**Rattle After Start – Upper Timing Chain –
Install Revised Tensioner**

MODEL 1995-96 MY
Sedan (4.0L) Range
VIN
See engine no.

ILLUSTRATION 1

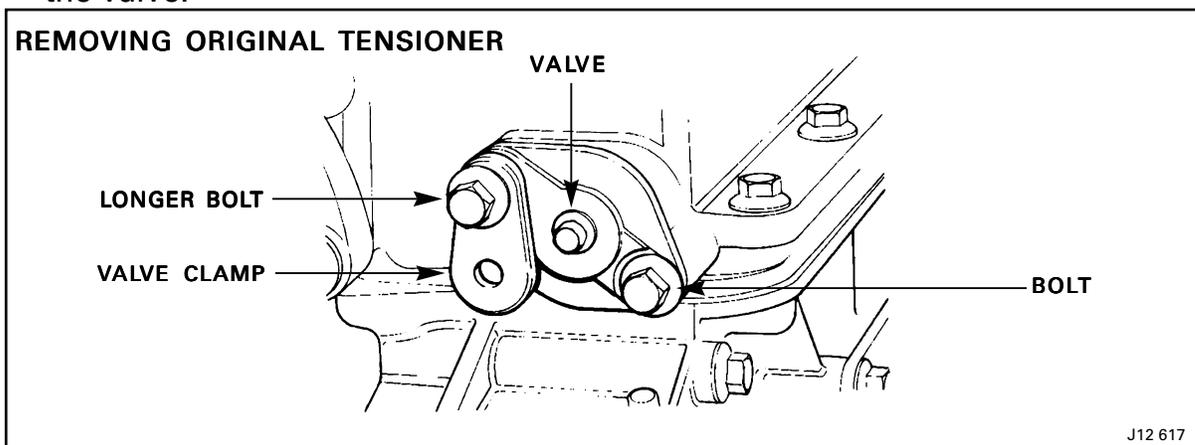
1. Remove the fuel pump relay and run the engine at idle to depressurize the fuel system.
2. Remove the longer bolt (Illustration 1), remove the valve clamp and remove the valve.

NOTE: The longer bolt and the valve clamp can be discarded since they are not required with the revised tensioner.

ILLUSTRATION 2

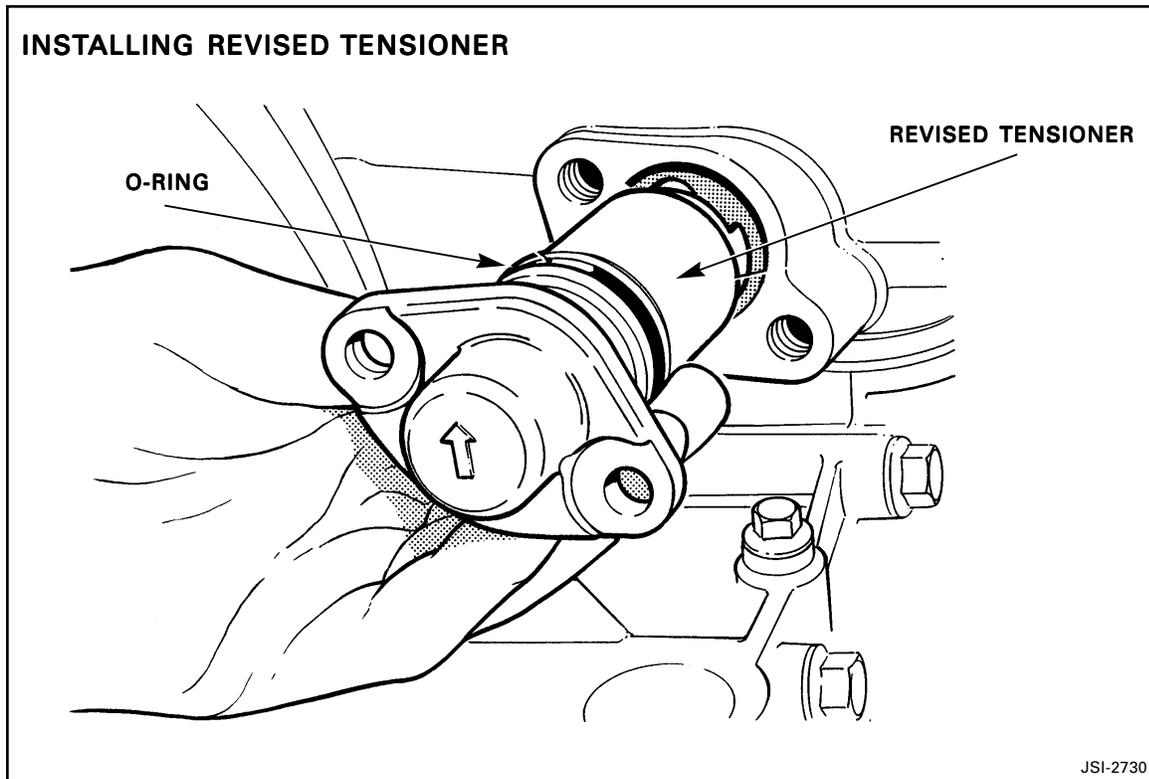
A revised tensioner with an integral oil reservoir has been introduced to overcome this condition starting with the following engine numbers:

5. Place the O-ring on the revised tensioner (Illustration 2) and lubricate it with engine oil.
6. Check that the mechanical tensioner within the piston is fully retracted (fully closed position.)
7. Install the tensioner assembly with a new gasket on the engine. Ensure that the arrow is pointing up and that the slotted head of the piston is aligned with the tensioner blade. (The bolt listed in the part information replaces the longer bolt previously discarded.) Torque the bolts to 16.2 - 20.7 lb. ft. (22 - 28 Nm.)
